DOCKETED	
Docket Number:	24-OPT-03
Project Title:	Soda Mountain Solar
TN #:	267965
Document Title:	Data request responses
Description:	Data request responses to: visual resources, figure updates, O&M building design, project alternative, grading numbers and building square footage.
Filer:	Hannah Arkin
Organization:	Resolution Environmental
Submitter Role:	Applicant Representative
Submission Date:	12/17/2025 5:01:04 PM
Docketed Date:	12/18/2025

From Hannah Arkin <hannah@resolutionenvironmental.com>

CEC Bighorn Sheep Questions

BESS LAYOUT

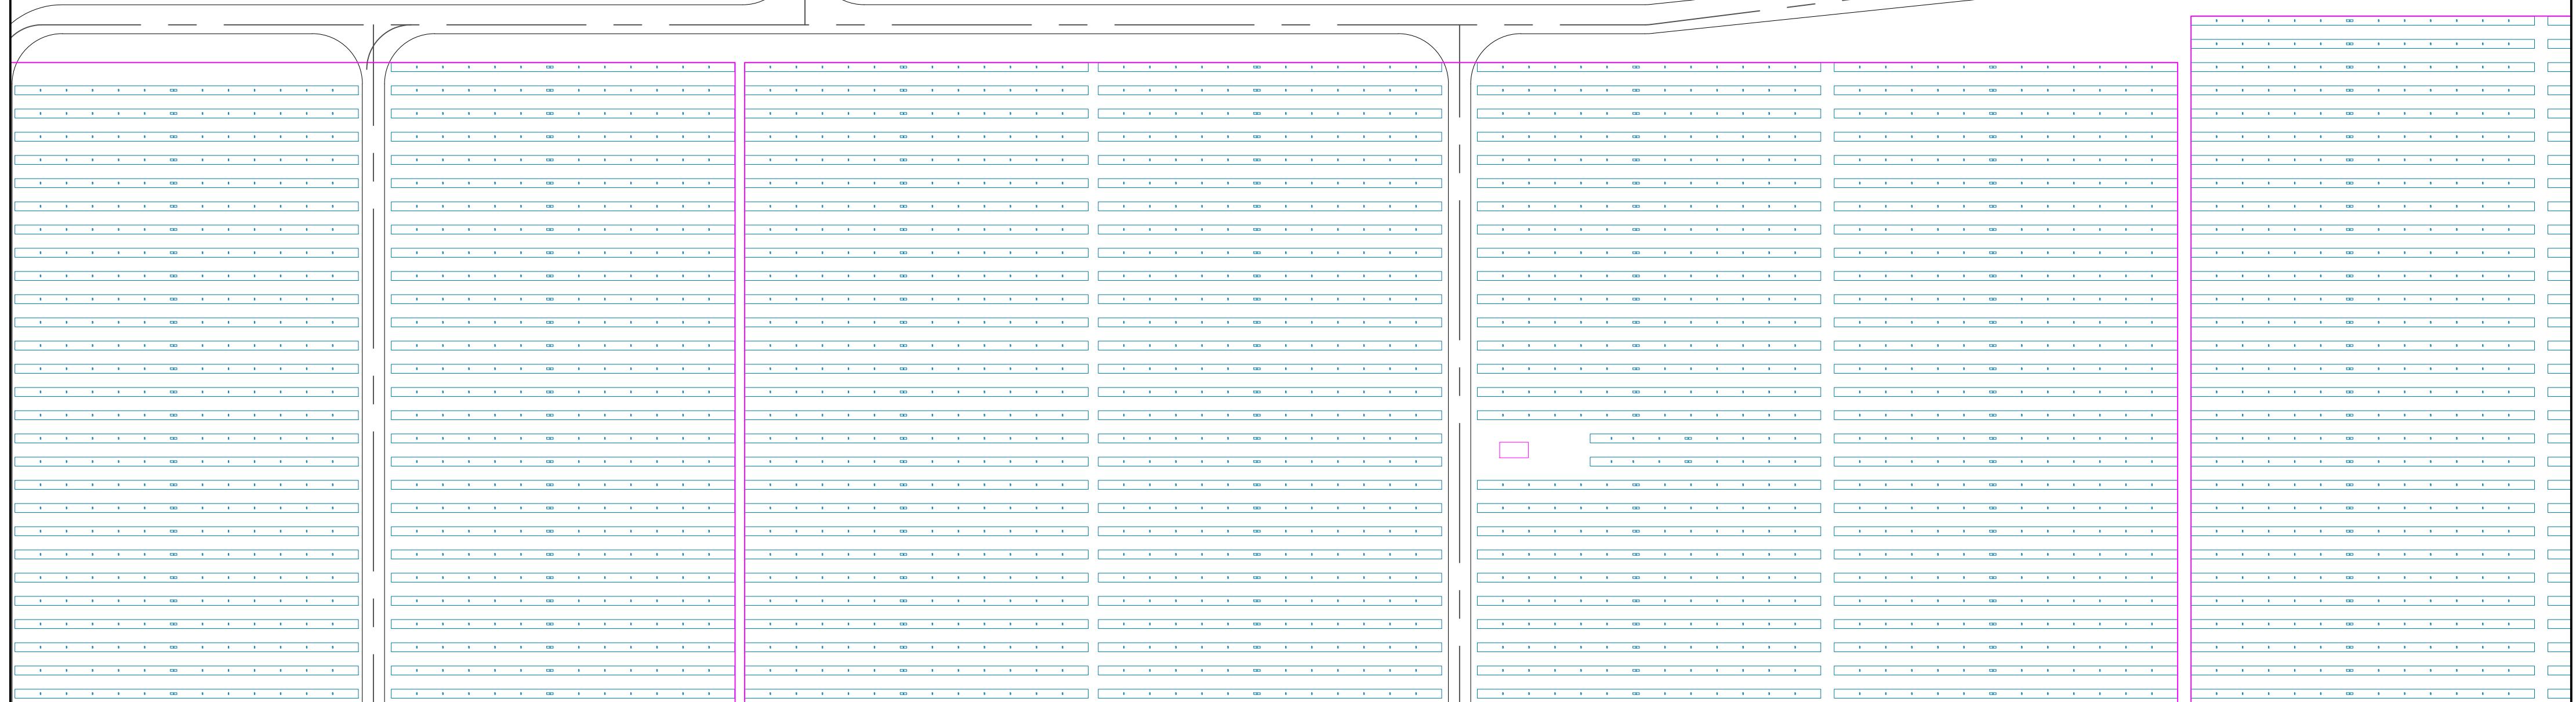
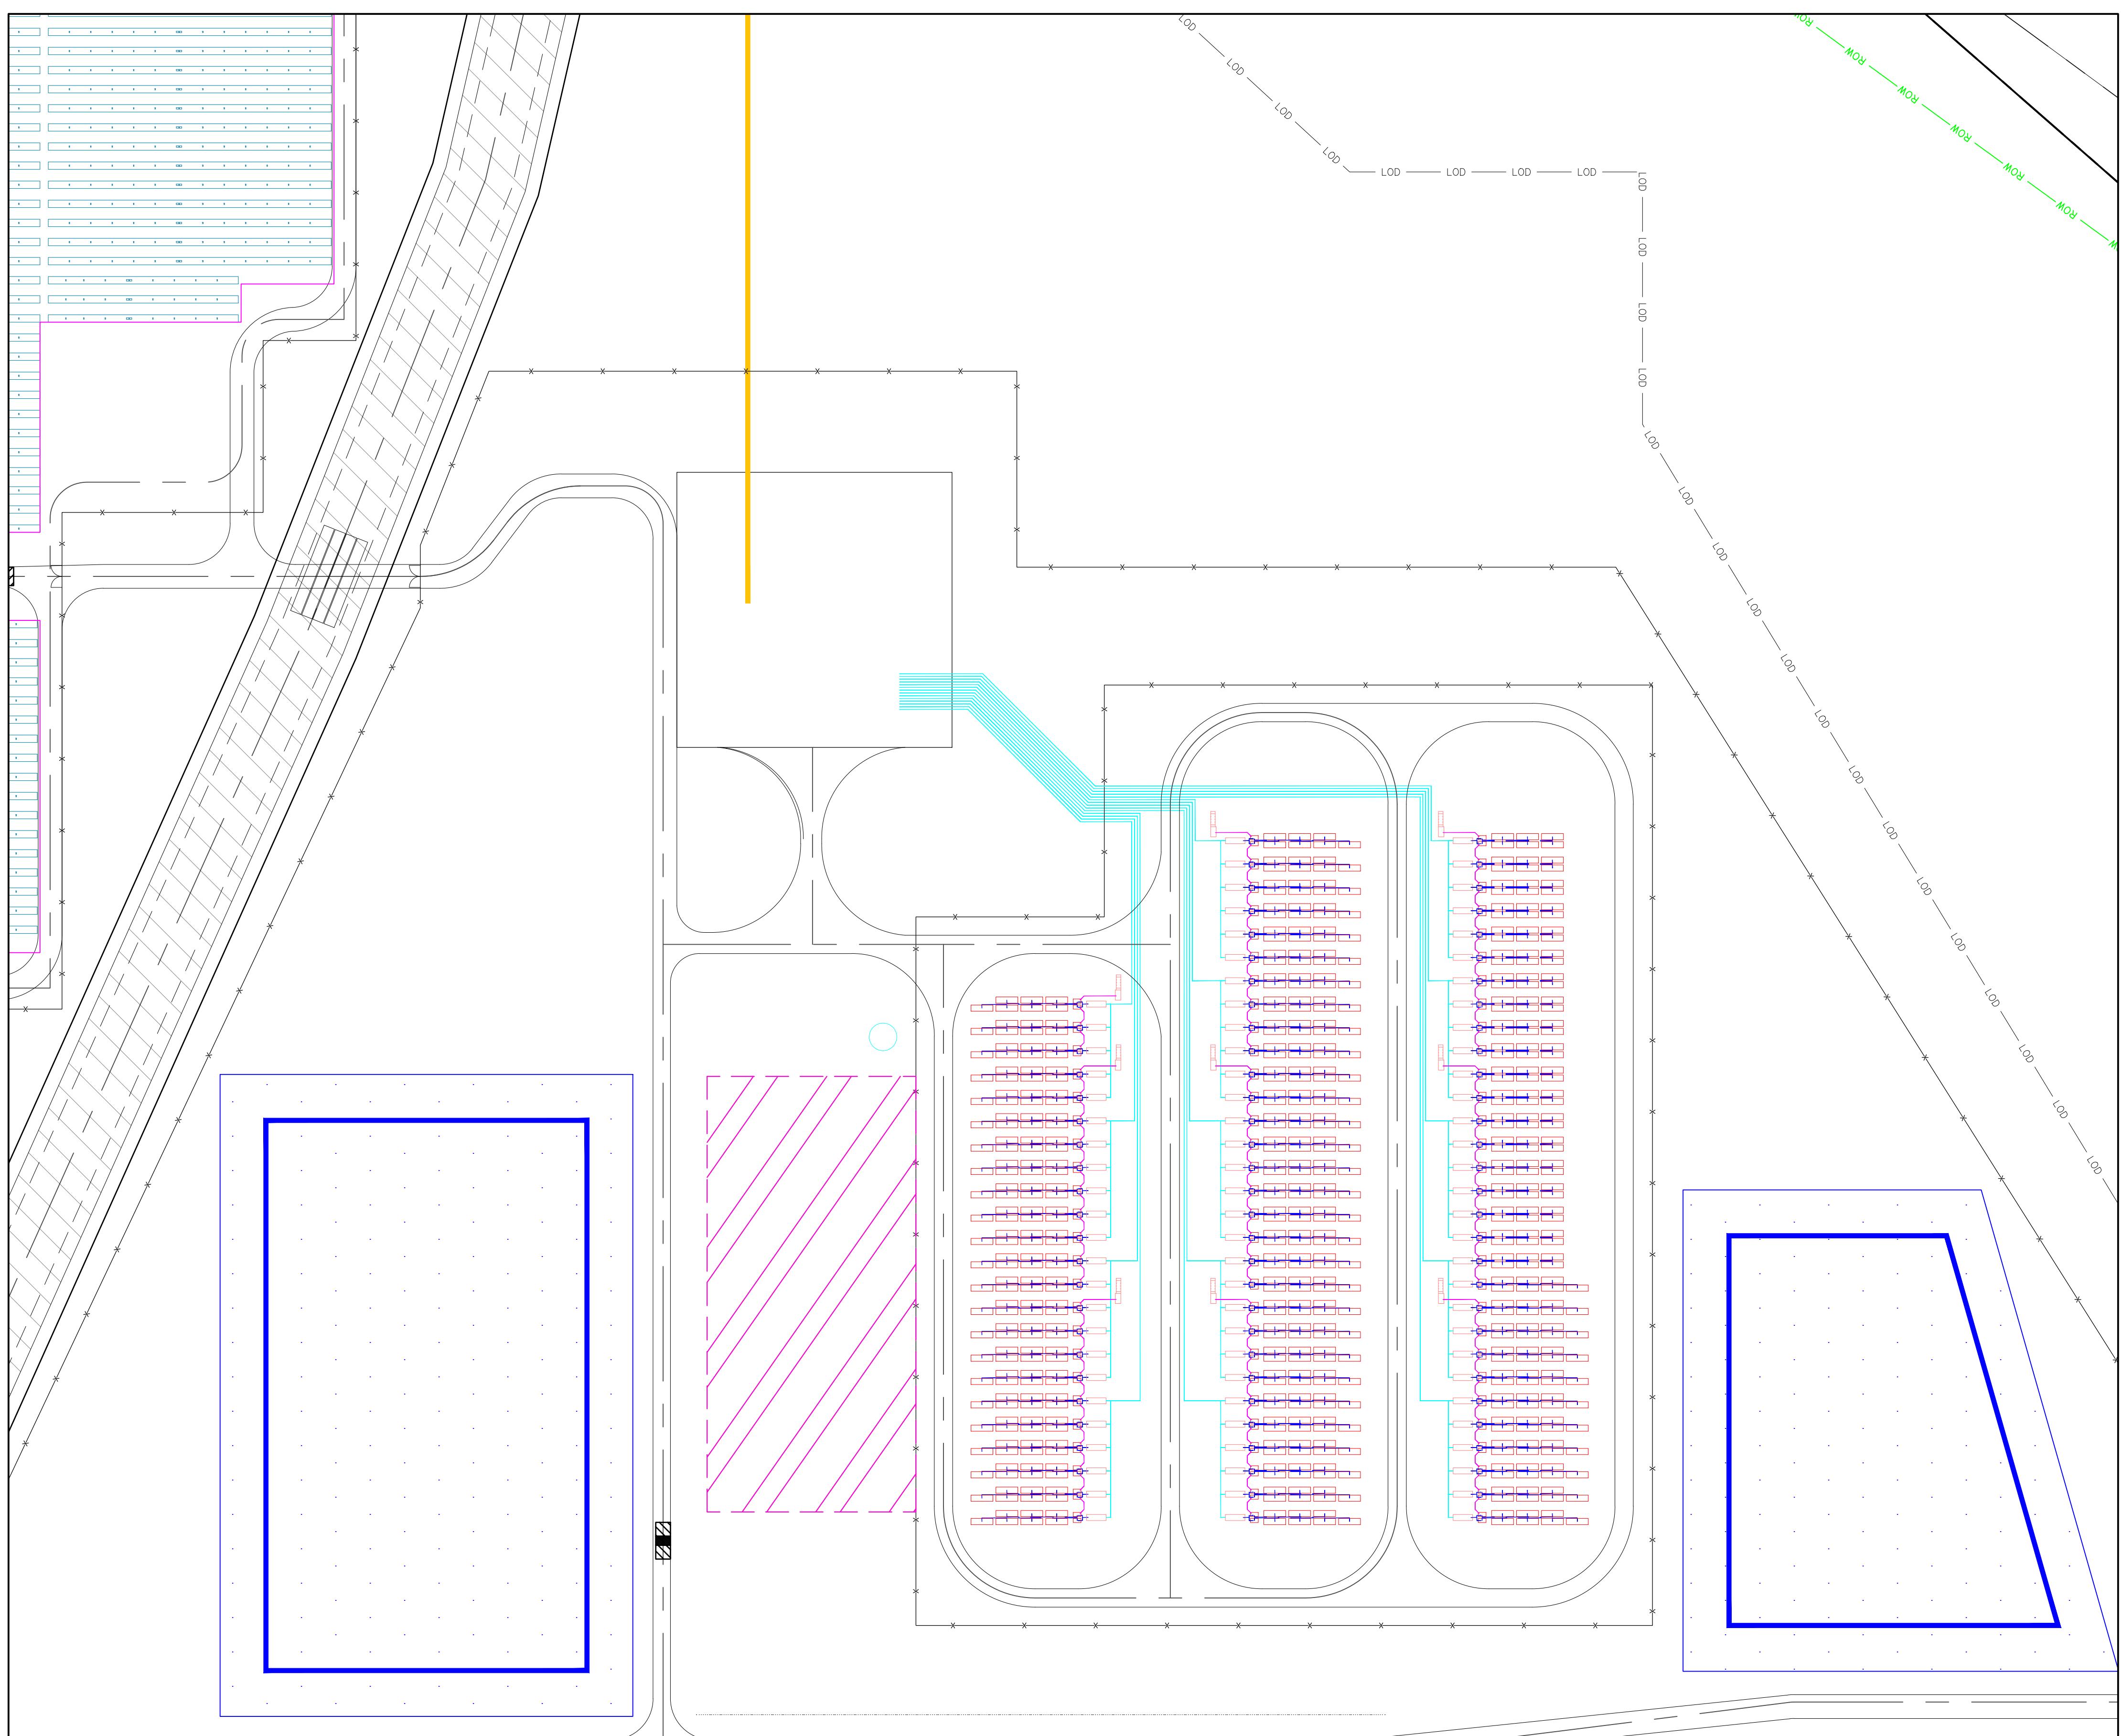
4. Can the BESS be moved away from the freeway and placed where the attached figure shows? If not, where else can it be moved to in order to be sufficiently far from the freeway. **The San Bernardino Fire Department has**

stated they have accepted the current location of the BESS and do not require any relocation of this facility. That said, the Applicant team has decided to move the BESS 500' east of the highway regardless in the attached alternative. This information will be added to the public docket. The proposed project has no change to the provided BESS site plan.
